NUREG–0847
Supplement No. 14

Safety Evaluation Report

related to the operation of
Watts Bar Nuclear Plant,
Units 1 and 2

Tennessee Valley Authority

Figure 5.1 Watts Bar 1, Analysis of Intermediate Shell Forging 05 Model Comparison, Service Levels A and B

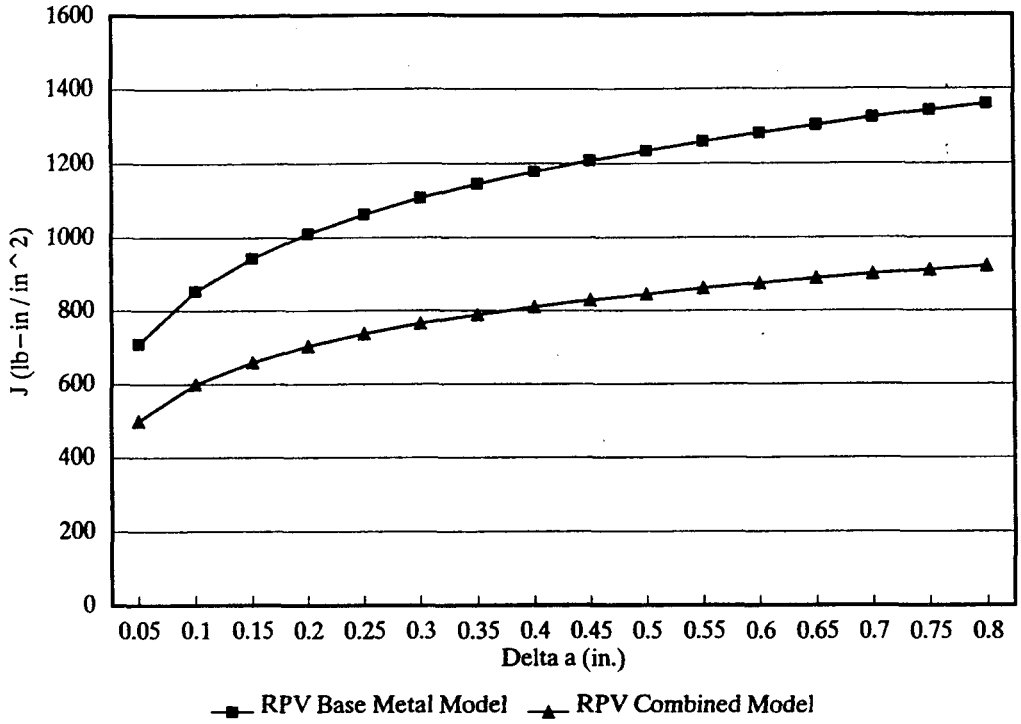
The Westinghouse report for Watts Bar Unit 1 also described the A302 Grade B bounding *J-R* curve analysis from WCAP-13587, Revision 1. As the Watts Bar Unit 1 reactor pressure vessel does not contain A302 Grade B, and sufficient information exists to enable determination of an A508 Cl 2 *J-R* curve as described above, the staff did not consider the A302 Grade B analysis.

The Westinghouse report for Watts Bar Unit 1 used the 100 °F/hr heatup/cooldown case as bounding for Levels A and B. This is consistent with the evaluation performed in WCAP-13587, Revision 1. For Levels C and D, the Westinghouse analysis used both peak stress and the overall magnitude of the through-wall stress as the criteria to determine the bounding transients. The resulting temperature at the crack tip (10% of wall thickness + cladding) was 487 °F for Watts Bar Unit 1 (see letter from W. Hodges dated April 21, 1994). Using these criteria, the applicant judged that a small steamline break was the limiting Level C transient, and large loss-of-coolant accident and large steamline break were the limiting Level D transients.

Figure 5.2 Watts Bar 1, Analysis of Intermediate Shell Forging 05
Establishment of Criterion #1, Service Leves A and B, SF=1.15

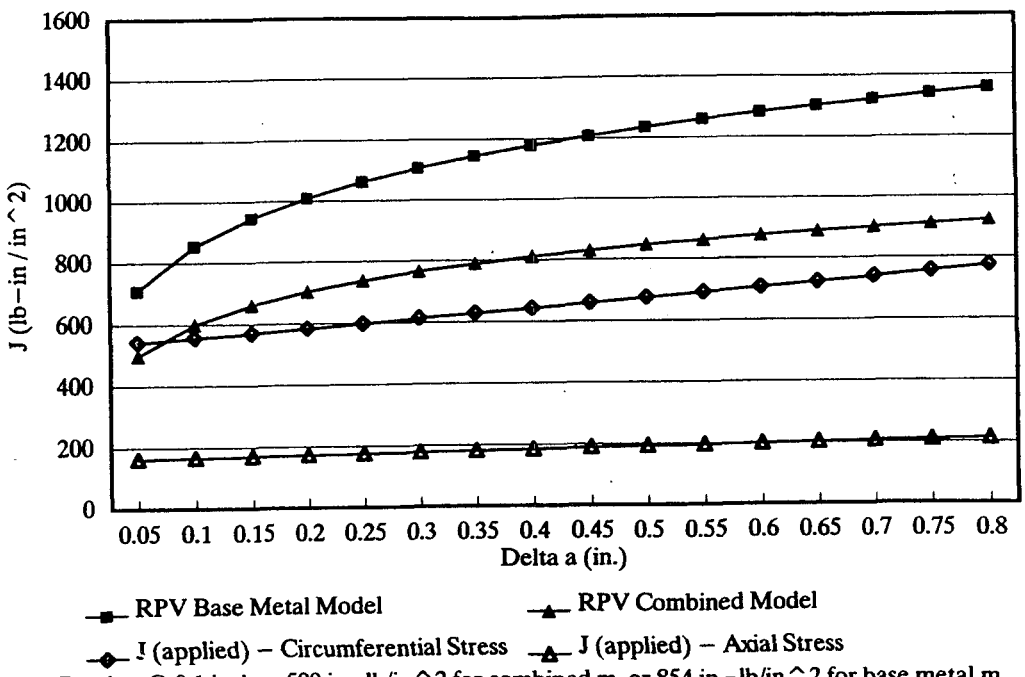
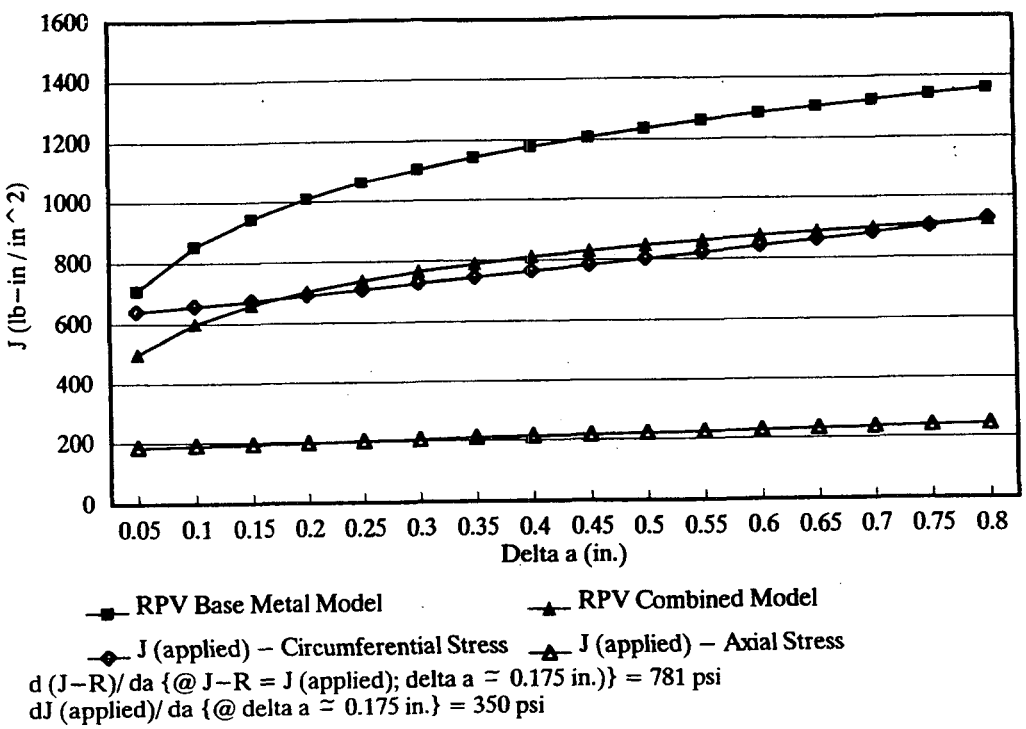
Levels A and B applied driving force and material resistance values for both the Westinghouse and staff analyses. The comparison in Table 5.1 is for K_{It} determined as per Equation 1 and the comparison for Table 5.2 is for K_{It} determined as per Equation 2. The comparisons were restricted to Levels A and B since these were found to be controlling. The Code Case N-512 criteria require that $J_{material}$ (J-R curve) be greater than $J_{applied}$ at 0.1 in. of crack extension (Criterion 1) and that the slope of the J-R curve (dJ/da) be greater than the slope of the $J_{applied}$ curve at $J_{applied} = J_{material}$ (Criterion 2). For this determination, the specified J-R curve is a conservative representation (mean - 2σ) of the fracture behavior. The safety factor on pressure for $J_{applied}$ is 1.15 for Criterion 1 and 1.25 for Criterion 2.

As shown in the tables and figures, forging 05 complies with the Code Case N-512 criteria for all of the conditions evaluated. The comparisons in the tables apply to the axial flaw case, which was found to be limiting. The figures show the $J_{applied}$ curves only for the case of Equation 1.

For completeness, the figures also show the $J_{applied}$ curves for the circumferential flaw case.
